Docket Item # 6 & #7 BAR CASE # 2018-00180 & 2018-00181

BAR Meeting May 16, 2018

ISSUE: Partial Demolition/Capsulation, Addition and HVAC Waiver

LOCATION: 410 South Fairfax Street

Figure 1: North/side elevation from private alley, the addition is indicated in the red rectangle.

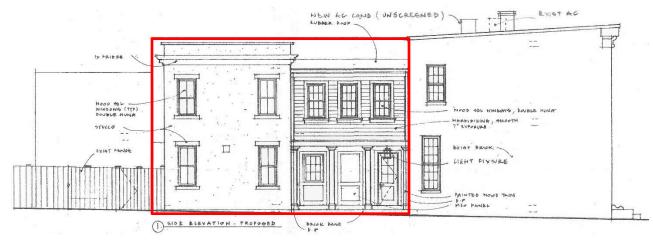
The applicant is requesting a Certificate of Appropriateness for a 710 square foot two-story addition to the east of the original house. The new addition is ten feet deeper than the current addition. From the north (side) elevation there will be two distinct styles (see figure 1).

The addition closest to the original house (17 feet and 10 inches long) will have the following finishes (reference figure 1):

- HardiePlank siding at a seven-inch exposure with a smooth finish
- Six-over-six simulated divided light (SDL) double hung windows on the second floor, a nine SDL casement window on the first floor, and a wood door with six SDL window.
- Doric pilasters
- Brick foundation
- Rubber membrane roof

The addition farthest away from the original house (19 feet long) will have the following finishes visible from the public right of way:

- Stucco finish
- Two-over-two SDL double hung windows

The applicant also requests a waiver of rooftop HVAC screening requirement for a new AC conditioner (see figure 1).

- 1. Any new rooftop mechanical equipment must be located on the roof of the hyphen.
- 2. Photographically document the condition of the existing historic alley prior to initiating any construction. The applicant shall be responsible for the mitigating any damage to historic materials caused by construction of this project.
